NL-17-0917

U. S. Nuclear Regulatory Commission  
ATTN: Document Control Desk  
Washington, D. C. 20555-0001Edwin I. Hatch Nuclear Plant  
Response to Request for Additional Information Regarding Relief Requests  
RR-16, RR-17, RR-21 and RR-22

**Edwin I. Hatch Nuclear Plant  
Response to Request for Additional Information Regarding Relief Requests  
RR-16, RR-17, RR-21 and RR-22**

TOP VIEW  
2E11-2HX-A-1 Configuration

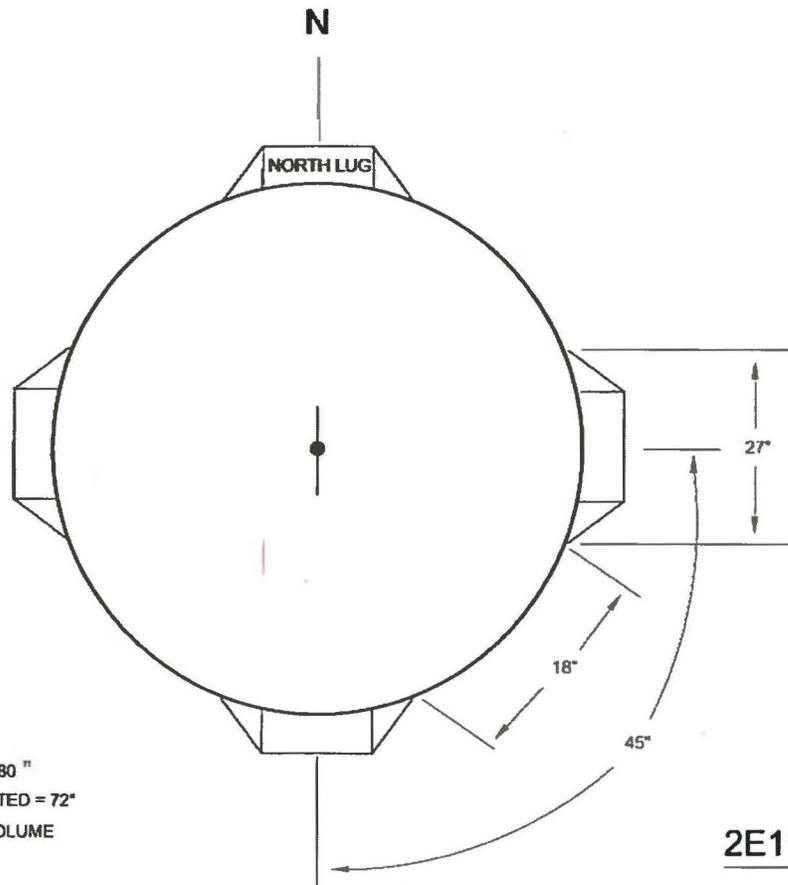
5. The staff reviewed the October 17, 1995 submittal identified under Section 8 (Precedents) of RR-21. In this submittal (which corresponds to a similar relief request for the third interval for weld 2E11-2HX-A-1), it is stated that 72% of the required volume was inspected. Please discuss the rationale and basis for the decrease in coverage to 40% during the fourth interval from 72% during the third interval.

Upon review of the initial submittal of RR-5 and the data sheets from the examination, the 72% percent coverage contained in the submittal for 2E11-2HX-A-1 was actually 72" of coverage out of 180" of total weld length, or 40% (72"/180"). The volume calculation has been consistent when comparing examination results. The figure on the next page shows the configuration documented in the data sheets. This error has since been documented in the SNC Corrective Action Program (CAP).

TOTAL EXAM  
TOTAL CIRCUMFERENCE = 180"  
TOTAL INCHES UNOBSTRUCTED = 72"  
 $72 / 180 = 40\%$  OF EXAM VOLUME

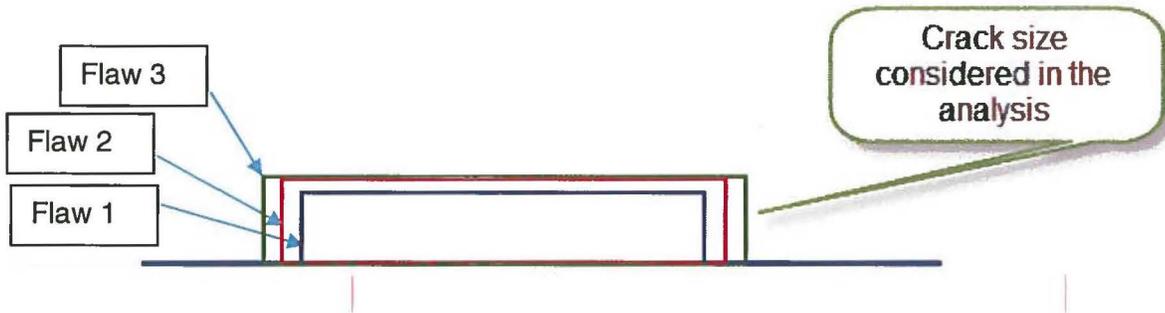
7. It is stated that “two UT indications were recorded on weld 1E11-2HX-A-I” and a fracture mechanics and fatigue crack growth evaluation was performed. It is then stated that “the flaw is acceptable” based on the evaluation. Please confirm that the indications were first evaluated to the requirements of ASME Section XI, IWB-3500 and that the analyses performed by Structural Integrity Associates were evaluated to the requirements of IWB-3600. Please also confirm that the flaw size assumed in the flaw evaluation bounds the size of the two UT indications.

Flaws	Depth (in)	Length (in)	Depth/Length
Flaw #1	0.12	0.75	0.16
Flaw #2	0.18	0.80	0.225
Flaw #3, Assumed Flaw	0.18	0.90	0.20

Since Flaw #2 is larger than Flaw #1, both in the depth and the length directions, only Flaw #2 needs to be considered. Assuming the a/l for Flaw #2 to be 0.2 makes the flaw longer and thus more conservative.

The fatigue crack growth (Section 6.2.4) was performed using an initial crack of depth = 0.18 inch and length = 0.9 inch ( $a/l = 0.2$ ).

For further clarification, ignore  $a/l$ , and only compare the depths and the lengths of the flaws. The flaw assumed for further analysis (Flaw #3) is larger than the observed flaws as shown in the sketch below.

# Coverage Plot 2C-1 Vessel to Flange Weld

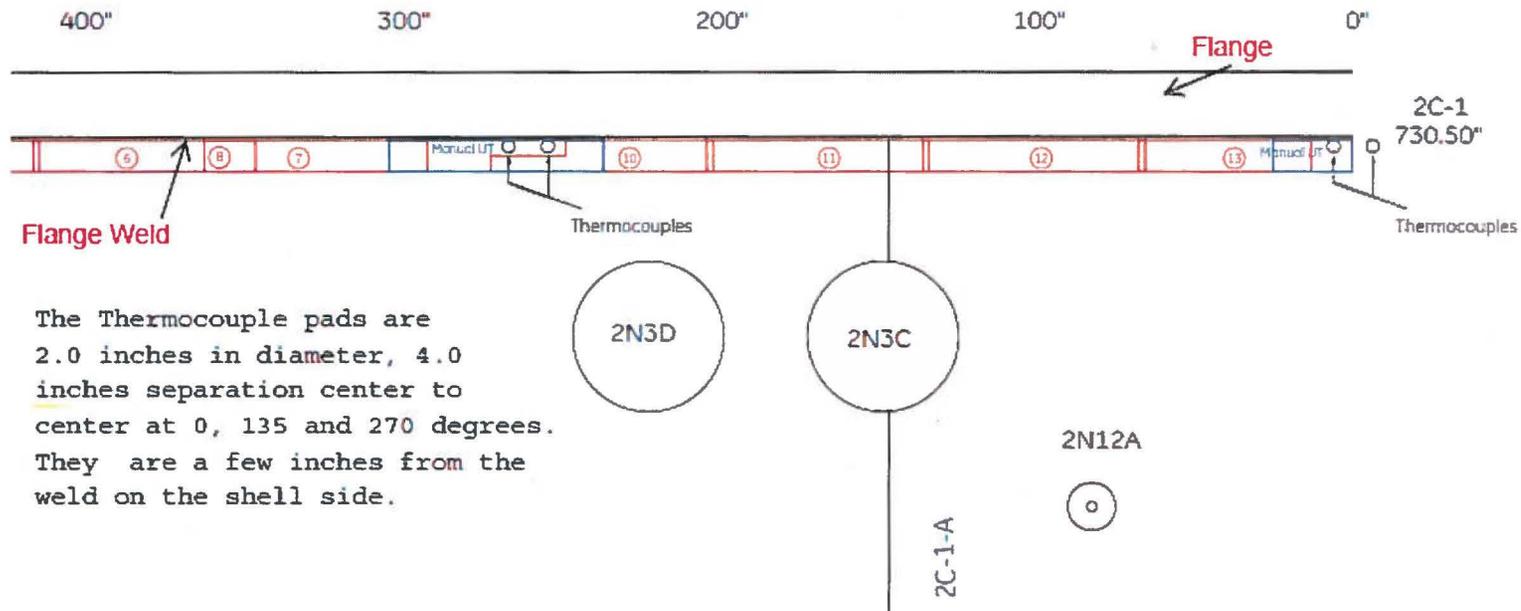
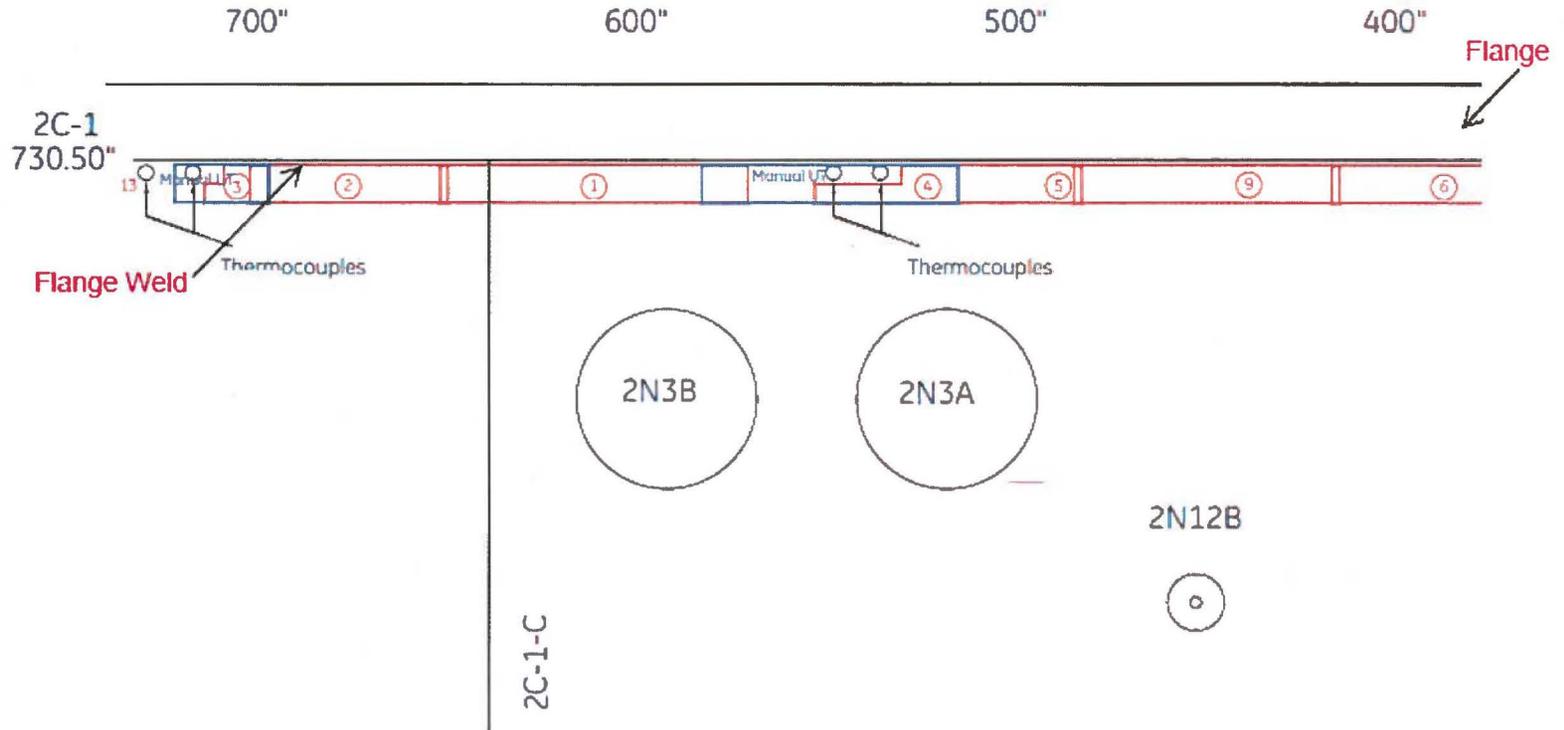
3. It is not clear how the three thermocouple pads are positioned around the shell circumference and obstructing the examinations. Please provide a diagram that

illustrates the position and size of the thermocouple pads on the shell side of the weld around the circumference.

The thermocouple pads are 2.0 inches in diameter, 4.0 inches in separation (center to center) at 0°, 135° and 270° on the shell side of the weld. The Attachment to this letter shows an excerpt from the General Electric Hitachi (GEH) nondestructive examination (NDE) report showing approximate placement within the examination area.

The Thermocouple pads are 2.0 inches in diameter, 4.0 inches separation center to center at 0, 135 and 270 degrees. They are a few inches from the weld on the shell side.

In the graphic above, the red boxes with numbered circles indicate automated scan areas. The blue boxes indicate where manual scans were performed in the location of the thermocouples to achieve greater coverage.
